SUBJECT: FOREIGN TRAVEL TRIP REPORT— NRC STAFF VISIT TO
WINTERTHUR, SWITZERLAND, TO OBSERVE SUMP STRAINER
TESTING PERFORMED BY CONTROL COMPONENTS,
INCORPORATED – DETAILED TECHNICAL DESCRIPTION

Observations of Testing at Control Components Incorporated
April 20 through 25, 2008

Figure 2 - CCI Test Loop for Salem

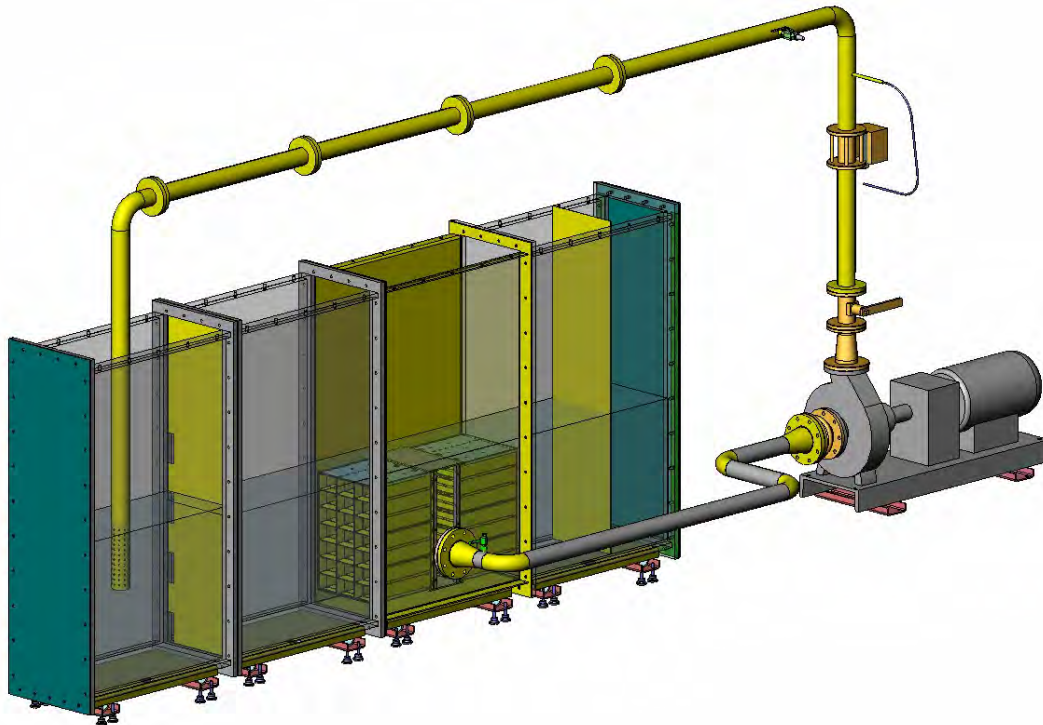
The test flume for this test was configured to model the installation of the Salem strainer. The test included a front and rear side of the strainer and a debris interceptor in front of the front side of the strainer. See Figure 2 which represents the test setup. The debris interceptor is not shown. It is placed several inches upstream of the front face of the strainer. In addition, the figure shows a plate installed between the return header and the strainer for the purpose of adding turbulence to the flume thus allowing complete transport of debris. This plate was not used in the testing observed by the staff. The bottom of the strainer was about three inches off the floor of the flume and there was a perforated plate across this bottom annulus at the rear side of the strainer.

- The staff noted that the Salem test setup should be inspected upon disassembly to ensure that non-prototypical bypass of the debris bed was not occurring.

- The staff also noted that for the Salem test (and others that credit debris settling) the flow characteristics in the test loop should be shown to be prototypical or conservative with respect to actual plant conditions. In addition, the settlement properties of the surrogate debris, including chemical precipitates, should be prototypical or conservative with respect to plant debris, including meeting the applicable WCAP-16530 settlement requirements.

Figure 3 - Fluffy Bed, Prior to Chemical Addition

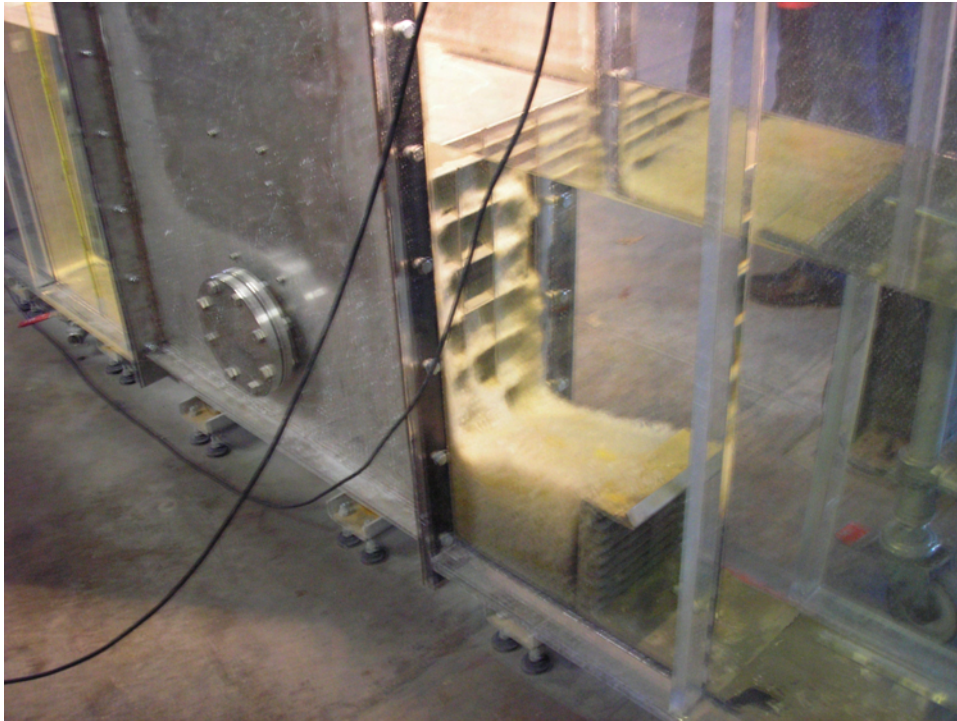
The staff observed the final mixing of the chemical precipitates. The precipitates were prepared per WCAP-16530 methodology. The pH of the sodium aluminum silicate (NaAlSi) was 10.2 prior to addition to the loop. The one-hour settlement properties of the precipitates were measured. The NaAlSi had a one-hour settled volume of 8.7 ml. This is slightly lower than the WCAP requirement for tests that allow near-field settling. 86 liters of chemical precipitate solution had been prepared and were added to the flume over a period of about 15 minutes. When the precipitate was added to the flume, a large fluffy bed of debris that had collected between the debris interceptor and front of the strainer was compressed significantly. See Figures 3 and 4.

Within about 5 minutes of adding the batch of precipitates, head loss increased to about 175 mbar (from the initial value of 141 mbar). Some chemical debris was observed to settle out in front of the debris interceptor. This debris was agitated with a drill driven propeller to resuspend it and allow it to transport to the strainer. After the agitation head loss increased to about 190 mbar. Some precipitate settlement also occurred on the rear side of the strainer. Salem personnel determined that this was prototypical of the plant and decided not to agitate this area of the flume. Although the decision seemed reasonable, the staff noted that Salem and CCI should justify that the settlement is prototypical of the plant, including both flow and debris settlement characteristics.

Figure 6 - Bed Collapse into Pockets-Salem

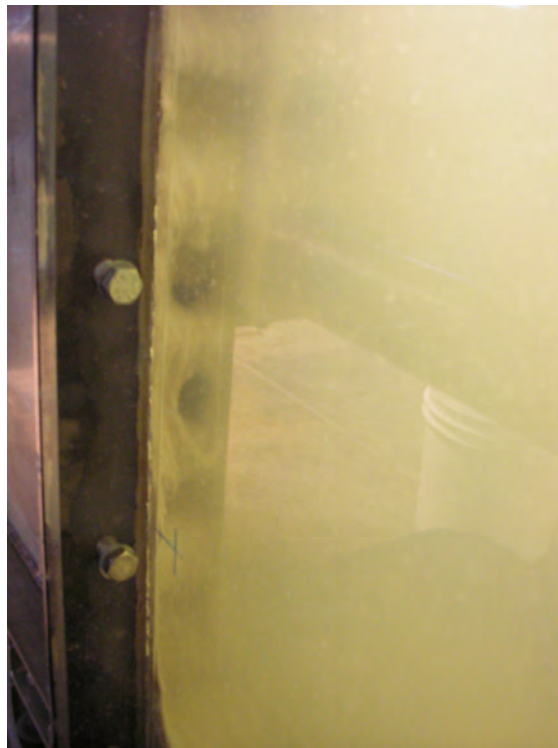
After the chemical additions, the staff also noted that the debris bed on the rear face of the strainer which resulted in a relatively uniform and flat coverage of the pockets collapsed inward to conform to each pocket. See Figures 5 and 6. Because the test fluid was quite cloudy it was difficult to closely observe this phenomenon. It is likely that the pockets were full of a relatively low density debris mixture that was compressed by the flow after the chemical precipitates made the bed less porous. The collapse of the bed into the pockets would have increased the flow area the fluid passed through and may have been the cause for the reduced head loss during the chemical additions.

Figure 11 - Palo Verde Under Water-Pre-Chemical Addition-Open Strainer Apparent

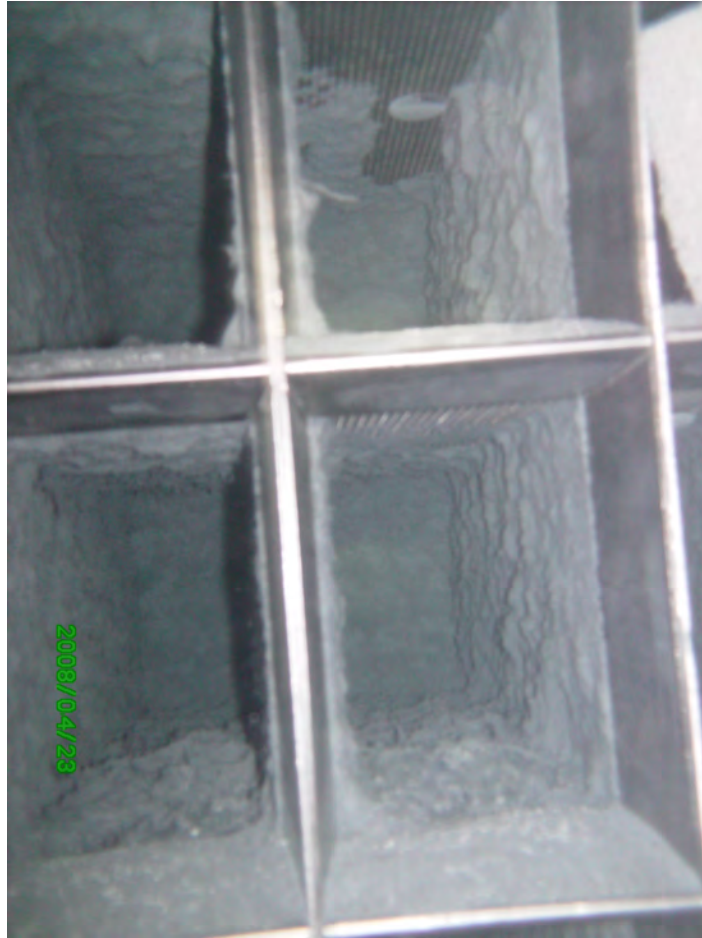
CCI and Palo Verde personnel stated that they had observed some clean strainer area prior to the addition of the chemical debris by using an underwater camera. The fibrous and particulate debris had already been added, but the particulate had filtered such that the water was relatively clean so that observation of the strainer surface was possible.

- During observations of the PVNGS testing, the staff observed that the test strainer had some areas where debris had not collected. Although head loss across the strainer increased due to the debris load, it was limited, likely by the small portions of open strainer. When the test flume was drained and the strainer and debris bed observed, it was apparent that the debris accumulated preferentially toward the upward facing horizontal surfaces of the strainer. This provides some indication that complex geometry strainers can provide advantages when compared to flat type strainers. However, the positive aspects observed during this testing cannot be applied to all situations. The prototypical flow patterns and debris loading can have a large impact on head loss. For example, the Salem test conducted on a similar type of strainer resulted in significantly higher head losses. The higher head losses were due, at least in part, to higher debris loading which completely covered the strainer surfaces.
